TOYOTA
Technical Service
Bulletin

Title: **NOISE FROM AUXILIARY PORT WITH EXTERNAL DEVICE**
Models: '06 – '07 4Runner, Prius, & RAV4 & '07 Camry, Camry HV, FJ Cruiser, Solara, & Yaris

TSB2810
BODY ELECTRICAL

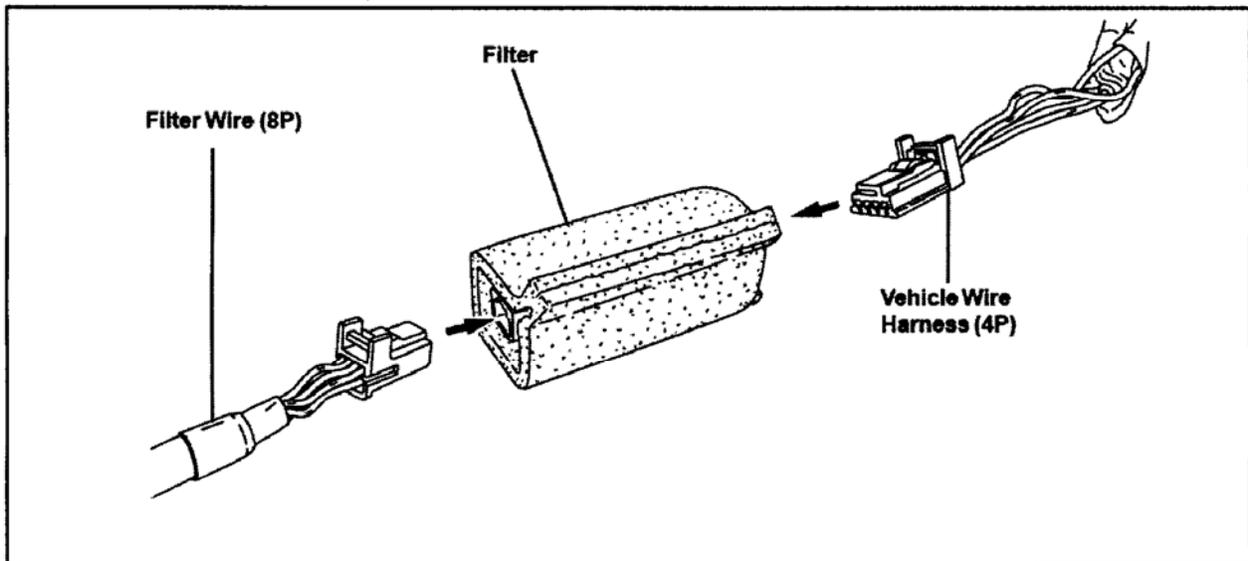
- A. Connect the vehicle wire connector (4P) into the filter, and connect the filter wire connector (8P) into the filter.

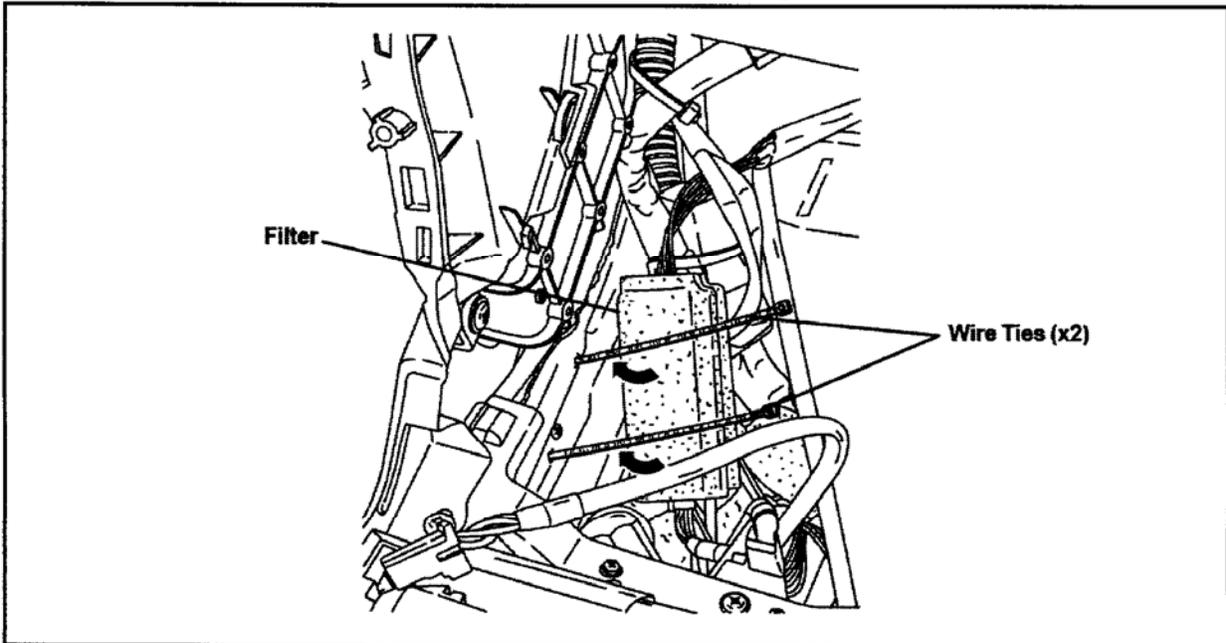
B. Secure the filter to the vehicle wire harness using wire ties.

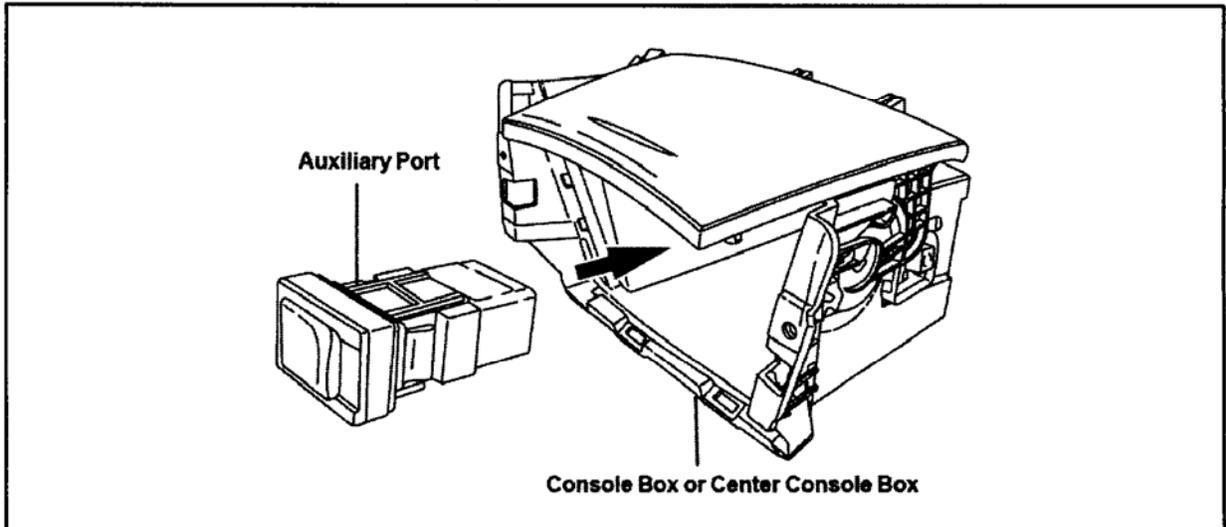
C. Install the NEW auxiliary port to the console box.

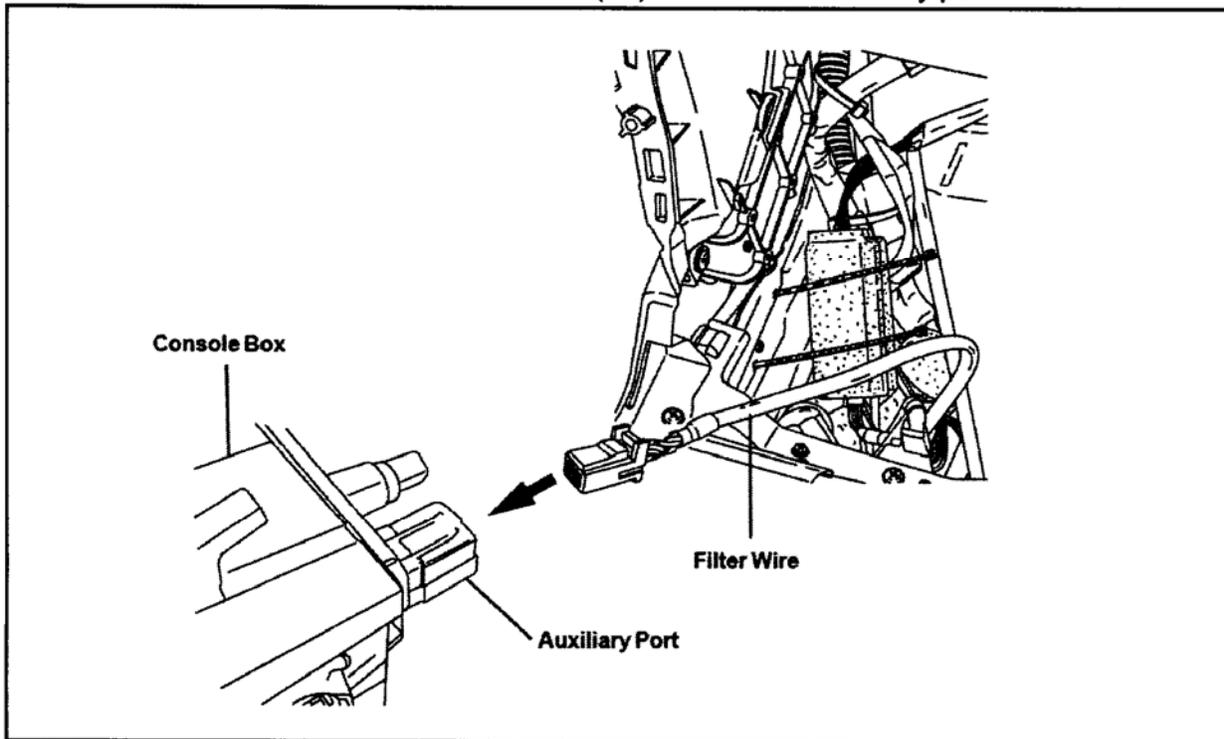
D. Connect the filter wire connector (8P) into the NEW auxiliary port.
